# **Attachment B**

<b>Correspondence from Applicant</b>
--------------------------------------

**From:** [Holly McNamara](#)  
**To:** [Jessica Symons](#)  
**Cc:** [Hannah Painter](#)  
**Subject:** RE: D/2024/36 & D/2024/446 - 372-382A Pitt Street, Sydney  
**Date:** Tuesday, 6 May 2025 11:23:13 AM  
**Attachments:** [image001.png](#)  
[image002.png](#)  
[image003.png](#)  
[image004.png](#)  
[image005.png](#)  
[image006.gif](#)  
[image013.png](#)  
[image014.jpg](#)  
[image008.png](#)  
[image007.png](#)  
[image009.jpg](#)  
[372 Pitt St Booster location .msg](#)  
**Importance:** High

Figure 49 – 1914 proposed alterations to the shopfront at 372 Pitt Street.

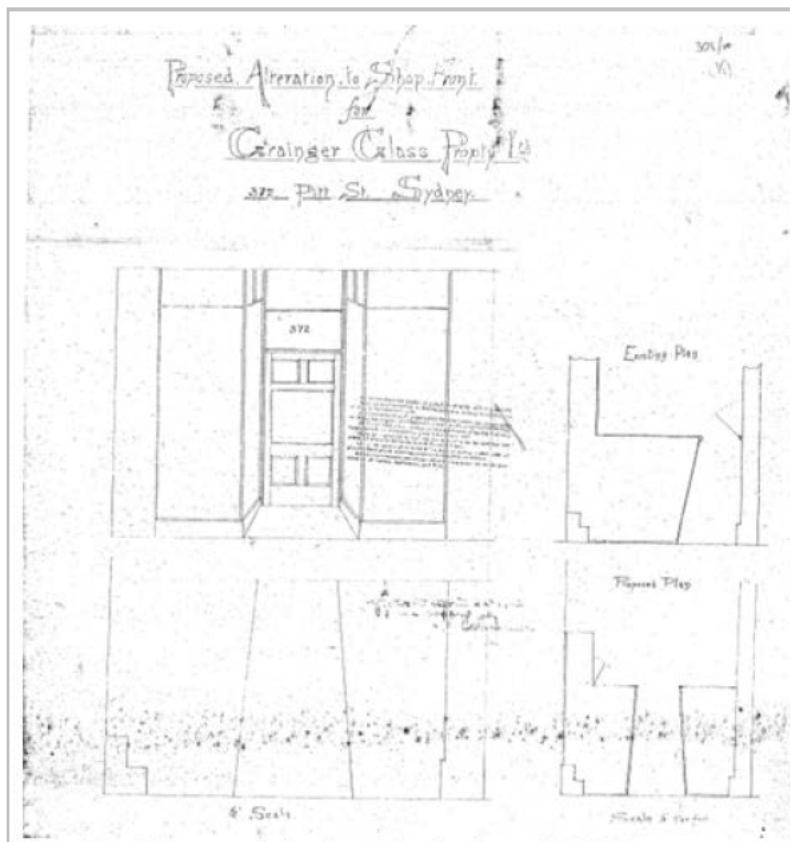
I have also replicated HIS Figure 49 below which I don't think is the correct reference as it shows previous alterations approved to the shopfront?

This HIS supports the removal and contemporary replacement of the shopfronts (noting that it is not a listed building). The conservation works relate to removing intrusive additions such as AC units etc, which remains as proposed. As such, we would request that Condition A19(a) and (b) are not included in the draft consent. Please could you review and confirm Council's response?
